SUBJECT: PLNPCM2019-01110 and PLNPCM2019-01111 – Rezone and Master Plan  
Amendment at 833 South 800 East

**PLNPCM2019-01110 and PLNPCM2019-01111  
Telegraph Exchanges Lofts - Zoning Map & Master Plan  
Amendments and Planned Development – 833 & 847 South 800  
East**

Re: PLNPCM2019-01110 – Master Plan Amendment  
PLNPCM2019-01111 – Zoning Map Amendment  
PLNSUB2019-01112 – Telegraph Exchange Lofts Planned Development

**A6** SITE PLAN  
AS1-01 SCALE: 1/16" = 1'-0"

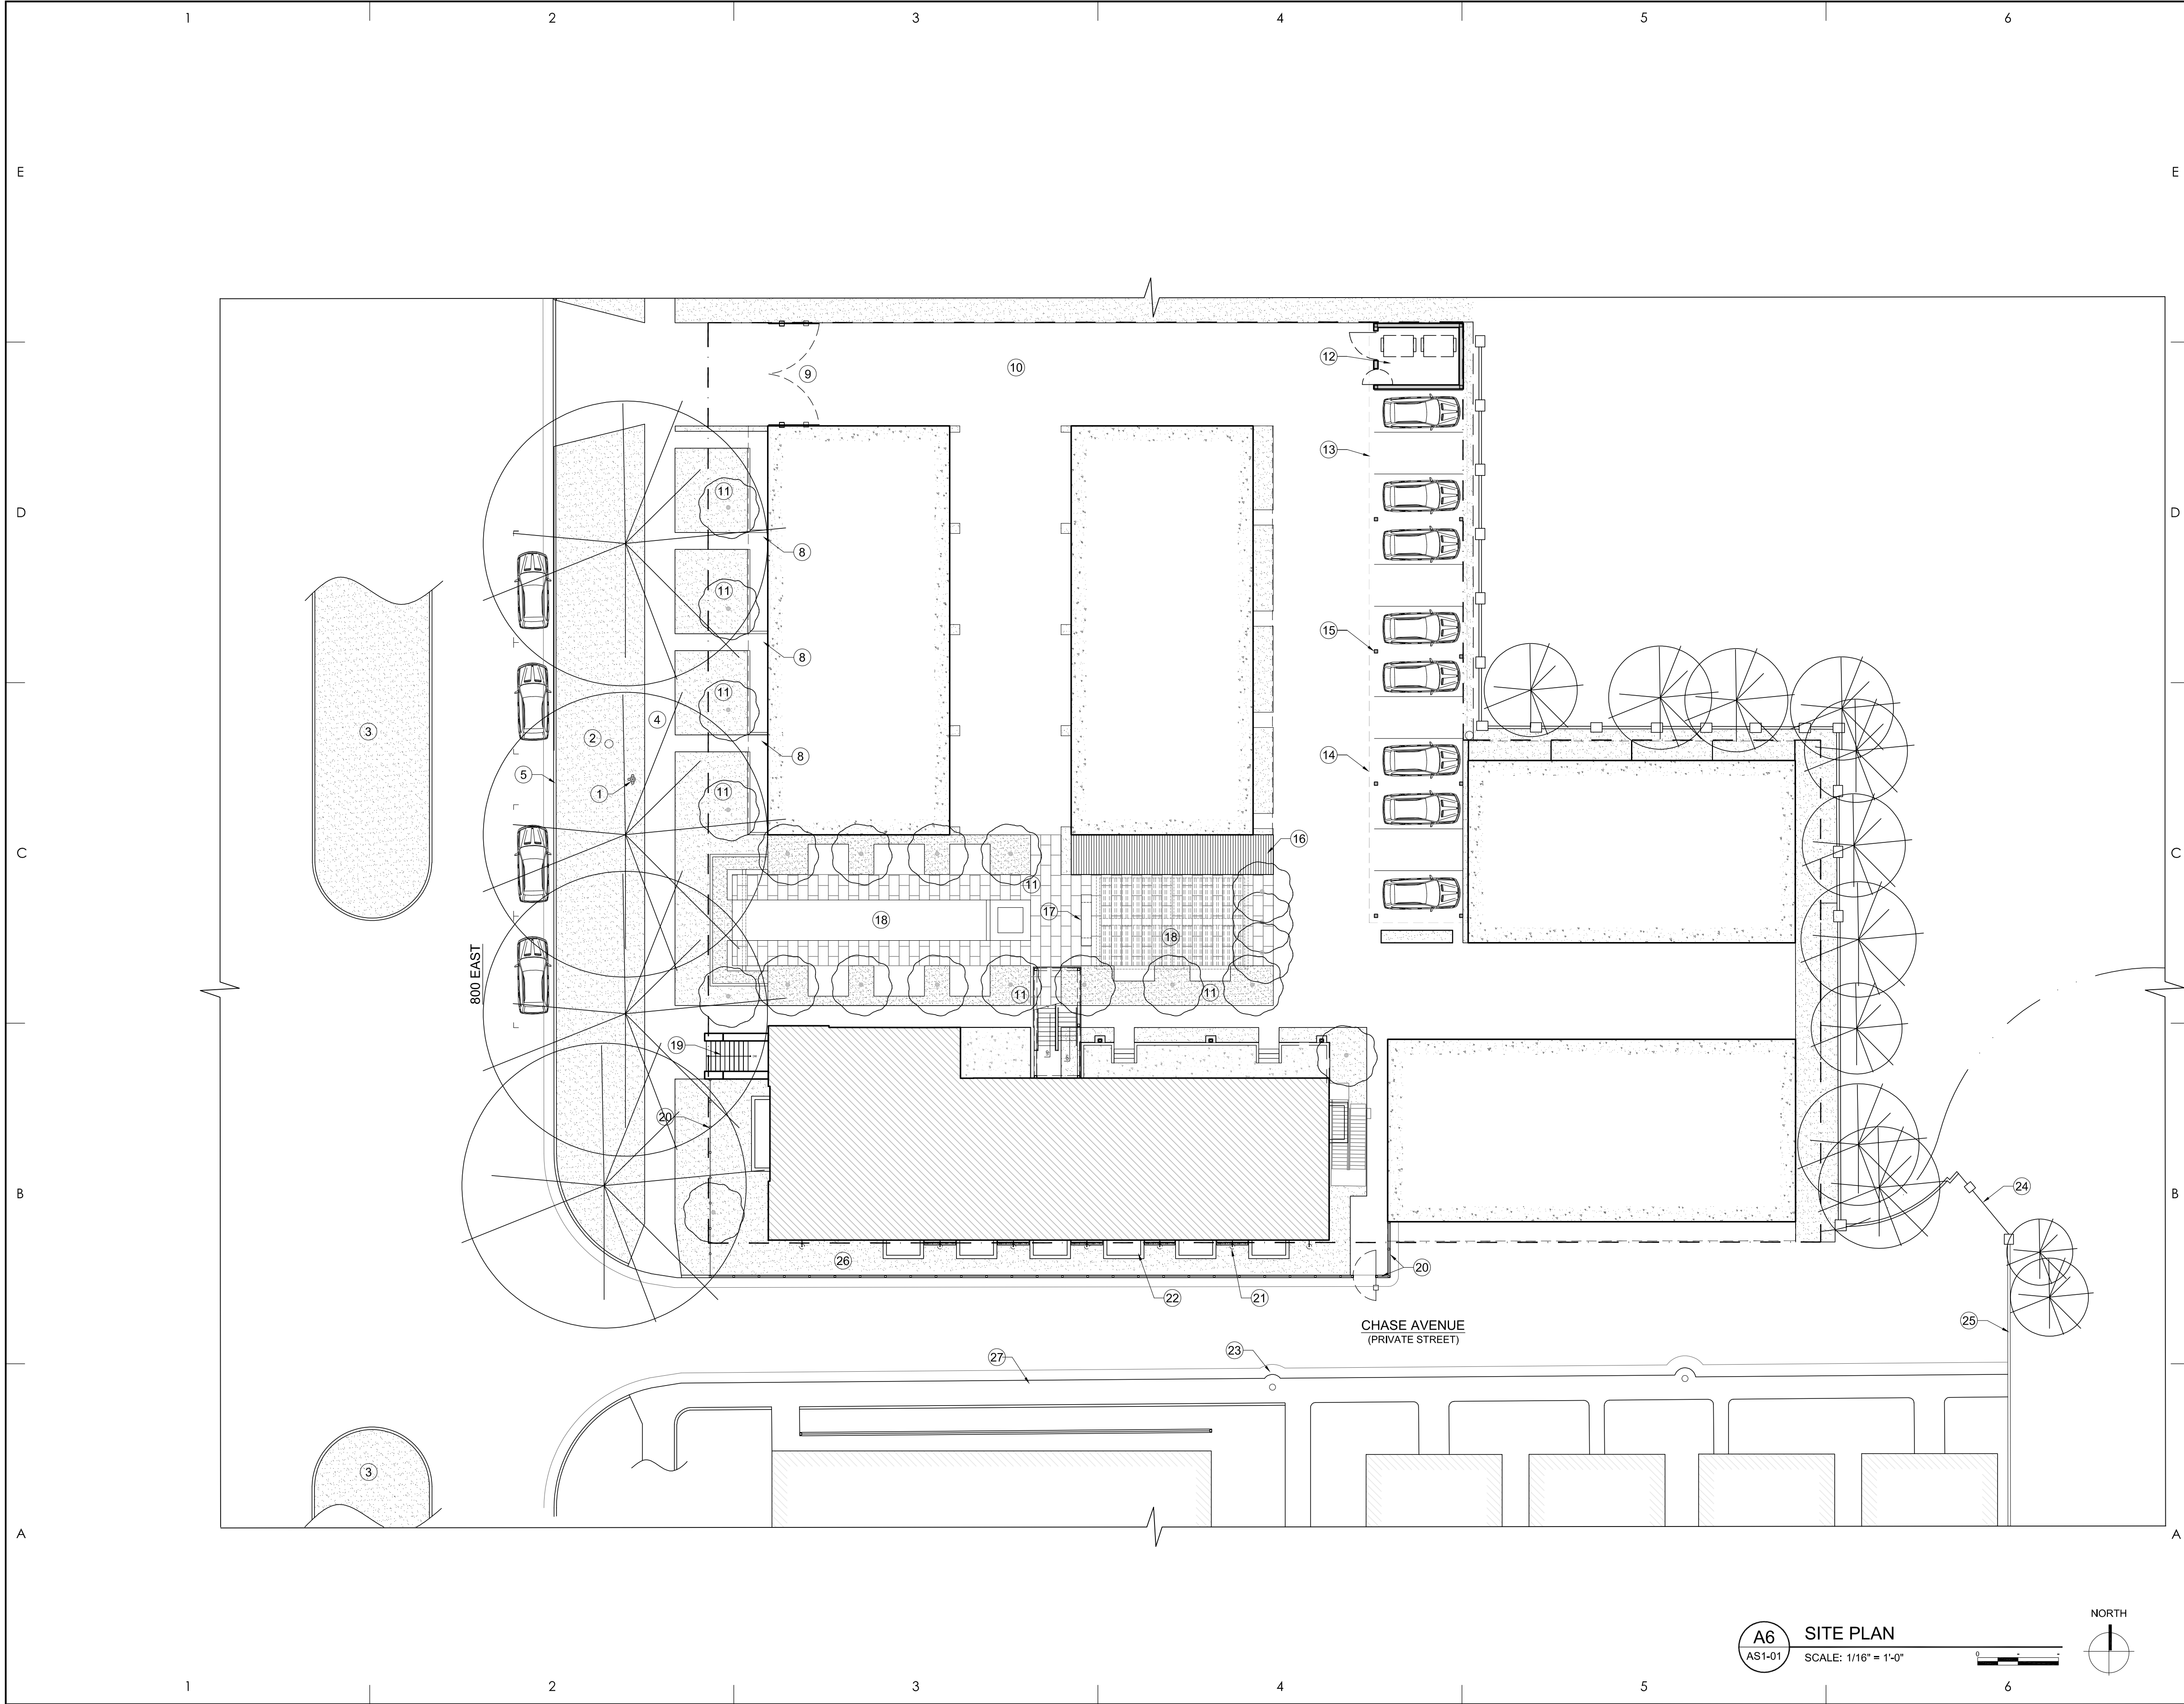
The Architectural Site Plan, sheet AS1-01, shows new sidewalk to be installed on the south side of Chase Avenue. SLC Engineering has no objection to this but since Chase Avenue is a private street, consent of the property owners who have rights to Chase Avenue must be obtained prior to installation of the sidewalk.

AS1-01

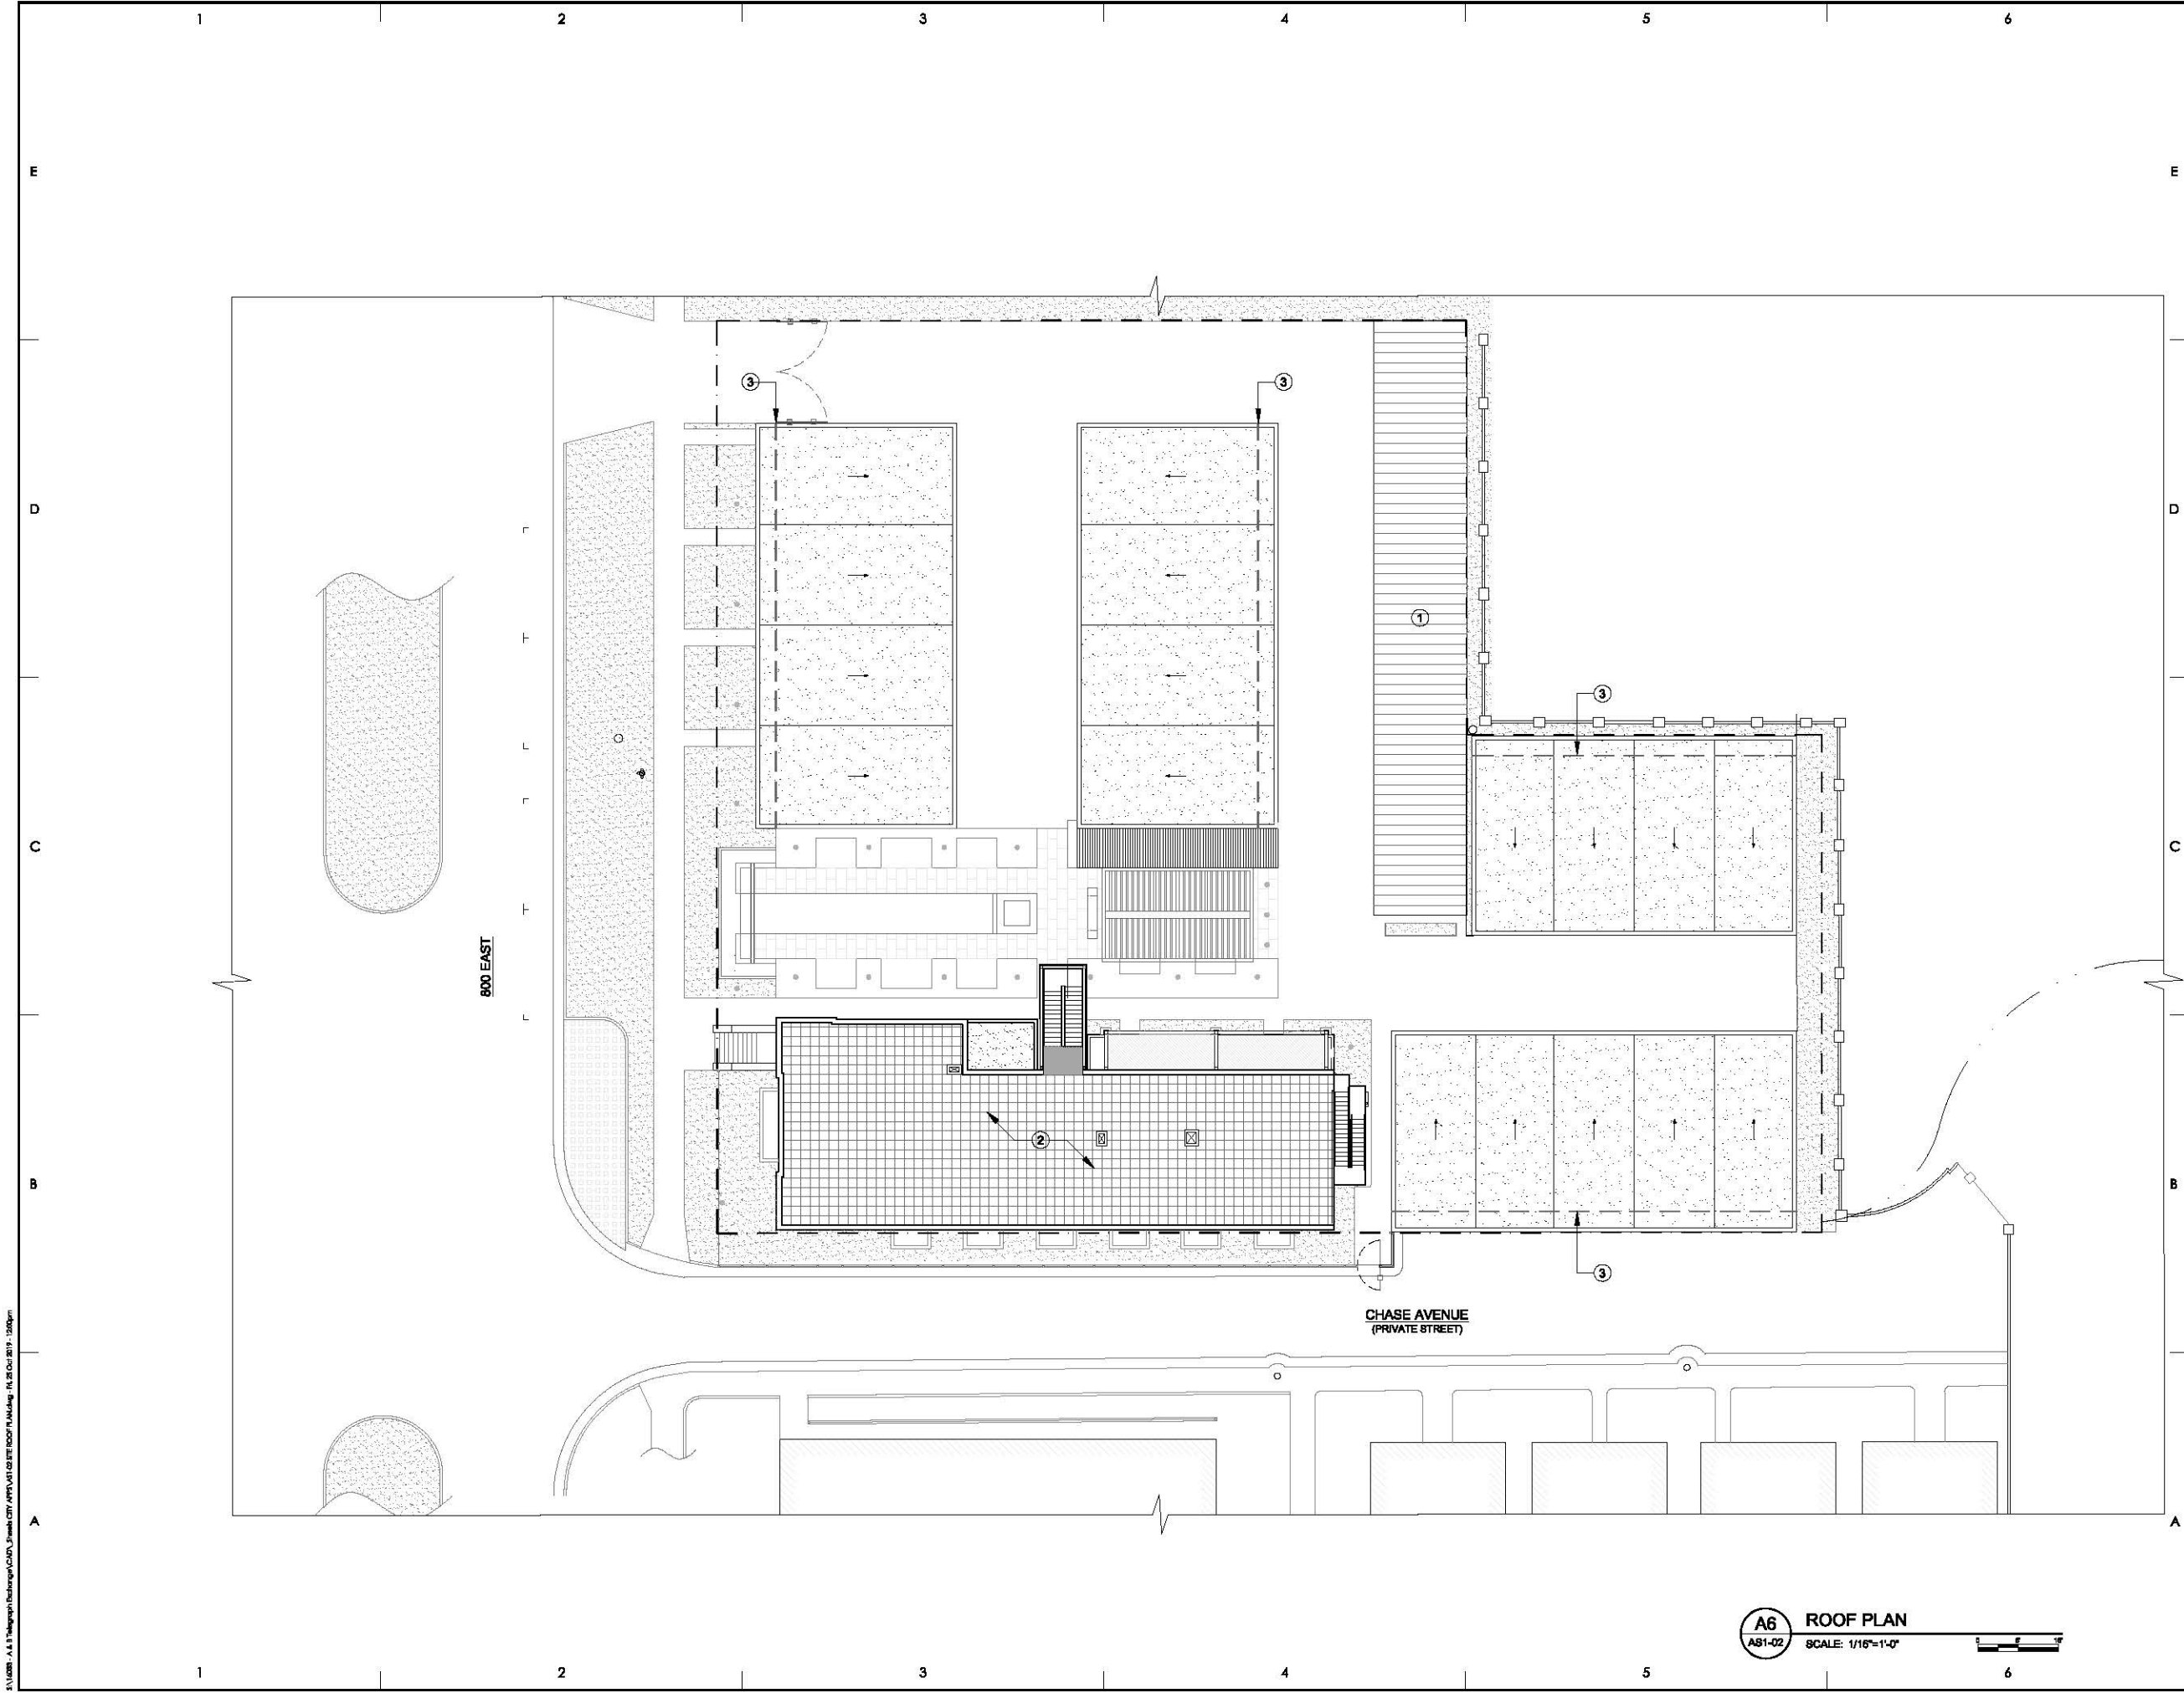
The Architectural Site Plan, sheet AS1-01, shows new sidewalk to be installed on the south side of Chase Avenue. SLC Engineering has no objection to this but since Chase Avenue is a private street, consent of the property owners who have rights to Chase Avenue must be obtained prior to installation of the sidewalk.
